- 5. Gruber Subdivision Ames Addition; KPB File 2024-046  
Edge Survey & Design, LLC / Ames  
Location: Stubblefield Drive  
Kalifornsky Area**

**ITEM #5 - PRELIMINARY PLAT  
GRUBER SUBDIVISION AMES ADDITION**

<b>KPB File No.</b>	2024-046
<b>Plat Committee Meeting:</b>	May 28, 2024
<b>Applicant / Owner:</b>	Brook and Gable Ames of Soldotna
<b>Surveyor:</b>	Mark Aimonetti and Jason Young / Edge Survey and Design LLC
<b>General Location:</b>	Stubblefield Dr in Kalifornsky area / Kalifornsky APC

**STAFF REPORT**

**GRUBER SUBDIVISION AMES ADDITION**

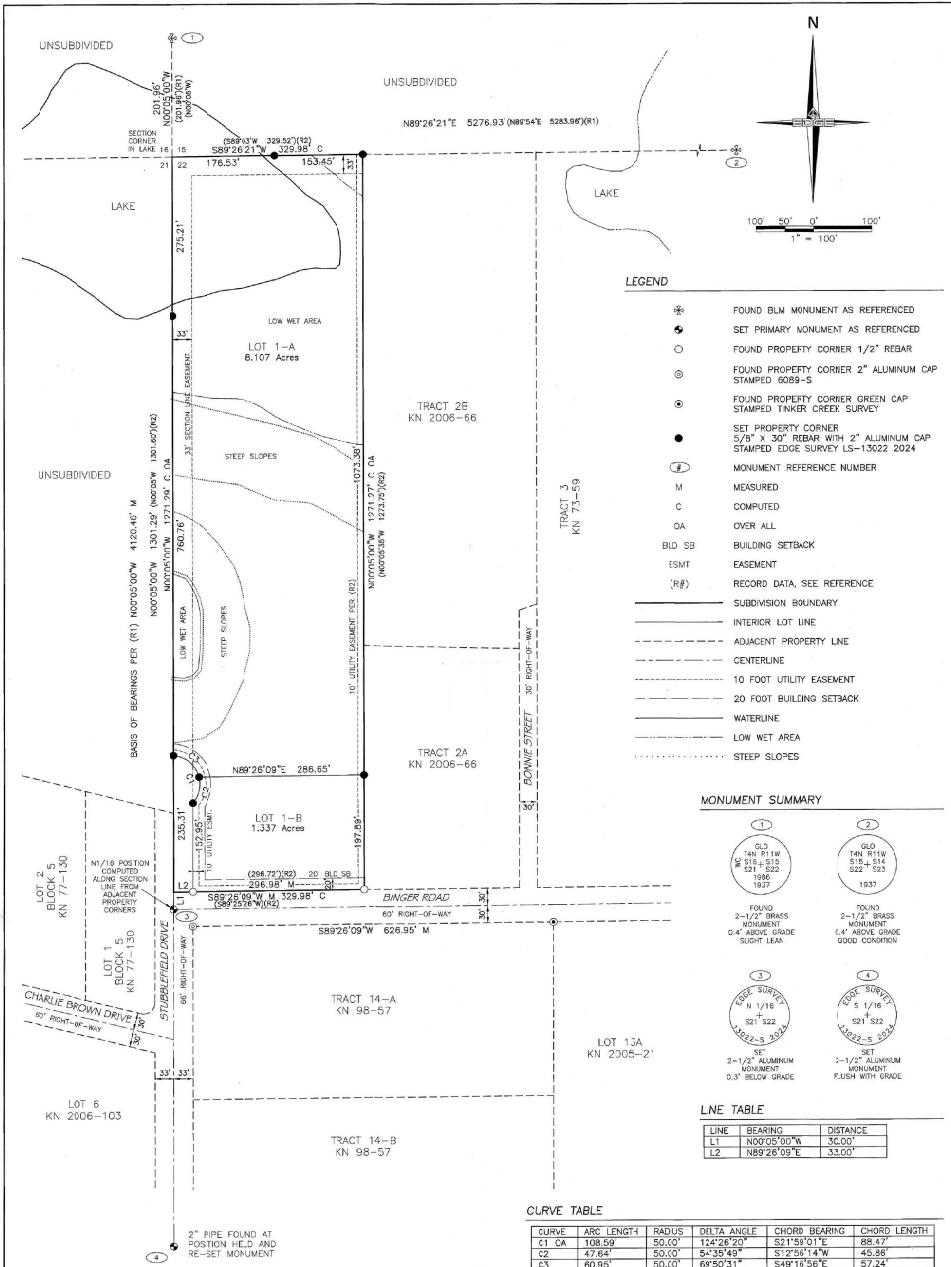
***The subdivision is affected by a section line easement as shown on the drawing. The easement should be shown on both sides of the section line if they exist on both sides.***

There are steep areas shown on the plat, identified as steep slopes. **Staff recommends:** the surveyor identify the direction of slope with either an arrow or label top and toe.

There does not appear to be any encroachments to or from the property across lines. There is a structure located on the property to the east that appears close to the property line. The surveyor should take note of its location to the property line when doing the field work.

HEA made comments as follows: the 10’ utility easement listed as being by KN 2006-66 should be referenced to KN 72-59 on the east side of the plat.

Add KPB No 2024-046 to title block

Show the temporary turnaround to the west from KN77-130

**Staff recommendation:**  
Label some of the prominent lakes on the map (eg. Echo Lake, Ashana Lake, Teack Lake, Leisure Lake, Reflection Lake, etc.)
- F. The location, width and name of existing and platted streets and public ways, railroad rights-of-way, easements, and travel ways existing and proposed, within the subdivision;

**Staff recommendation:**  
Label the temporary turnaround shown on the parent plat
- G. The status of adjacent lands within 100 feet of the proposed subdivision boundary or the land status across from any dedicated rights-of-way that adjoin the propose subdivision boundary, including names of subdivisions, lot lines, block numbers, lot numbers, rights-of-way; or an indication that the adjacent land is not subdivided;

**Staff recommendation:**  
Correct the plat label number to the east
- M. Approximate locations of slopes over 20 percent in grade and if contours are shown, the areas of the contours that exceed 20 percent grade shall be clearly labeled as such;

**Staff recommendation:**  
Show direction of slope with an arrow or label top and toe

Add the date of May 28, 2024 to the Plat Approval
